SUBJECT: Forwards response to 980402 RAI re proposed TS modifying emergency condenser circulating water (ECCW) sys, dtd 970828. Licensee requests that staff complete review of subject TS amend & design features description by 980420.

Subject: Oconee Nuclear Station  
Docket Nos. 50-269, -270, -287  
Proposed Revision to Technical Specifications  
for the Upgraded ECCW System  
Technical Specification Change # 96-09  
Supplemental Information Letter #4

ATTACHMENT 1  
RESPONSES TO STAFF QUESTIONS

0HPSFL0001

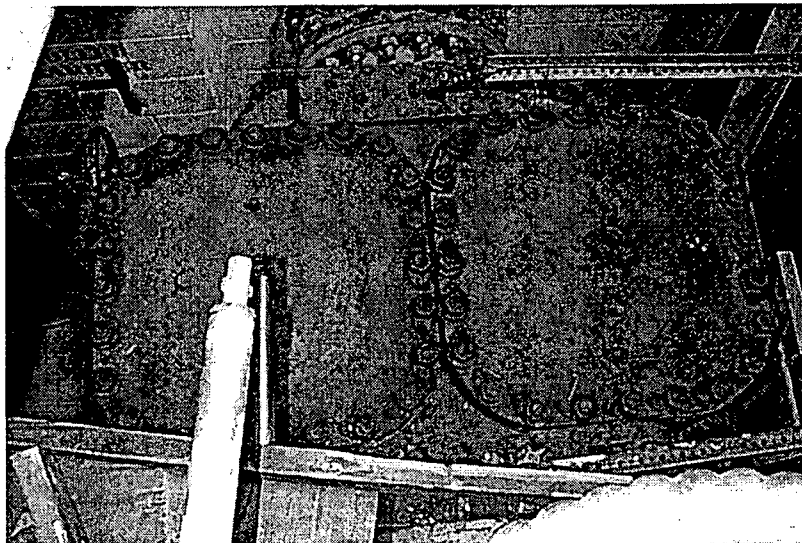
The strainers are also shown on OM-240-4. These strainers are constructed of cast iron material. ONS Systems Engineer ( Jean Robinson) indicates that strainers 0HPSFL0001 AND 0HPSFL0002 weigh approximately 13,200 lbs (wet) and strainer 0HPSFL0003 weighs approximately 2100 lbs. (wet). The strainer assembly also includes two gate valves which are attached directly to the strainer housing.

0HPSFL0003

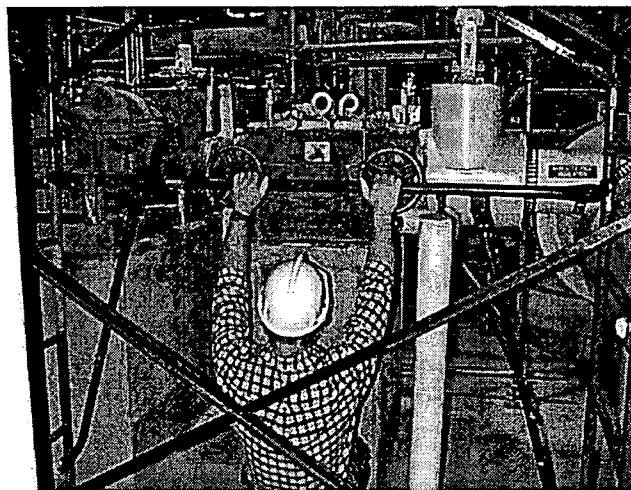
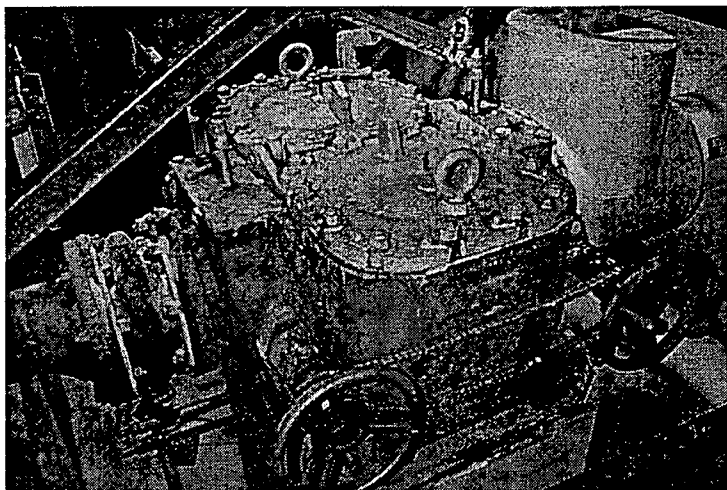
"passive equipment such as piping; filters; and electrical penetration assemblies". The memo to file was generated to ensure completeness and documentation. No SEWS form is required for these items. The strainers and their associated piping have been rigorously analyzed with the strainers treated as unanchored, in-line components, and assuming vertical support only from strainer pedestals. All associated pipe stresses were found to be within design limits. The strainer shims for OHPSFL0003 will be replaced.
